**SUBJECT: Wireless Telecommunications Facility Permit Application
(T-Mobile Site # LA33664E)**

NOTICE OF INCOMPLETENESS

**Subject: First Screencheck Comments - Wireless Telecommunication Facility
Permit T-Mobile Site #LA33664E; W/O 10876 Culver Blvd**

**ATTACHMENT 1
FIRST SCREENCHECK COMMENTS
WIRELESS TELECOMMUNICATION FACILITY PERMIT
T-MOBILE SITE #LA33664E – W/O 10876 CULVER BLVD**

SHEET NUMBER:
A-3

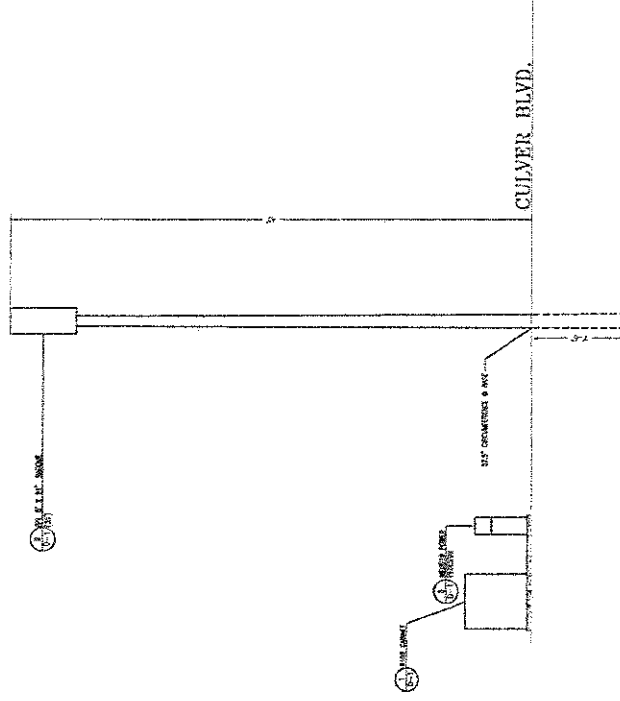
32. Add a note to the plans specifying the color of the pole. The pole shall be a neutral, non-glossy color.
33. Add a note to the plans indicating that the radome will be painted to match the color of the pole.
34. Add a note to the plans indicating that the equipment cabinet will be painted to match the color of the pole.
35. Add a note to the plans indicating that all cables shall be fully concealed.
36. Add a note to the plans that a sign shall be placed on the equipment cabinet that lists a telephone number to contact in case of emergency.
37. Provide a slimmer radome that is more in scale with the pole.

Notes: - Specify color of pole

- Indicate Pole name will be painted to Match pole color
- Indicate Address will be fully connected
- Indicate a sign will be placed on cabinet with phone number for Emergency Contact.

SHEET TITLE:
EQUIPMENT
DETAIL
 SHEET NUMBER:
D-1

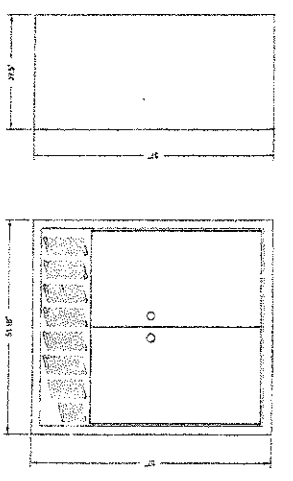
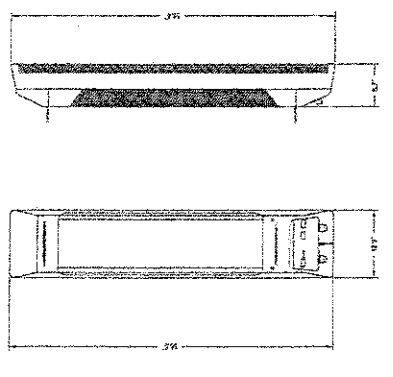
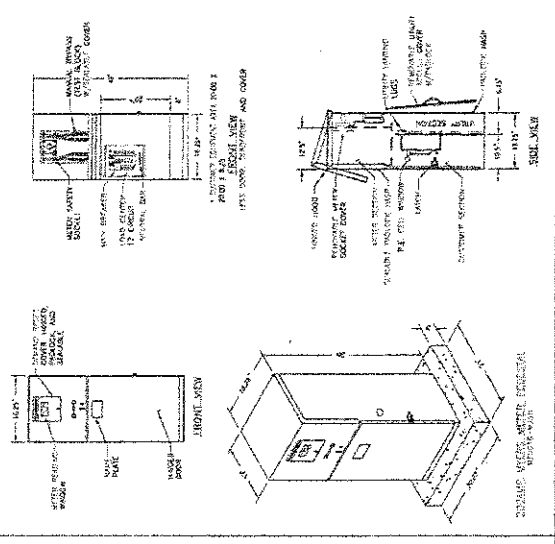
38. Provide detail for radome including height and diameter dimensions

Provide detail for
 radome.

SHEET TITLE:
CONCRETE PAD
 SHEET NUMBER:
D-2

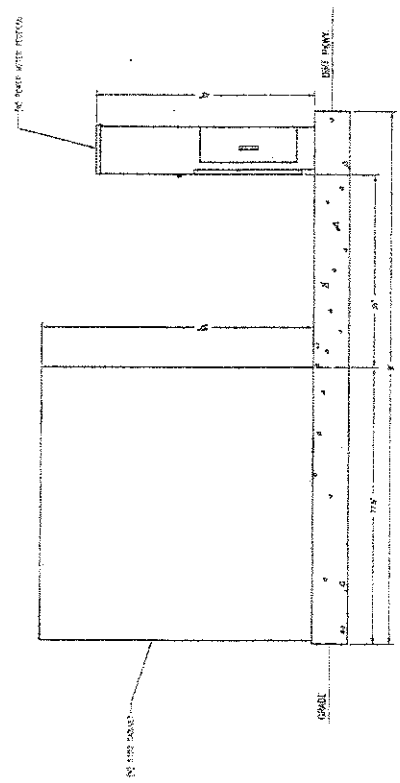
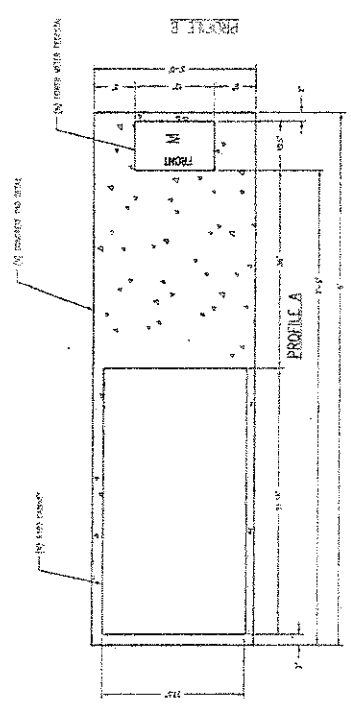
39. Decrease the size of the concrete pad to minimize the impact to the landscaped parkway.
40. Provide landscape screening around ground equipment. Depict landscaping on Sheet D-2.

*Decrease size
 of concrete.
 Locate equipment
 closer together.*
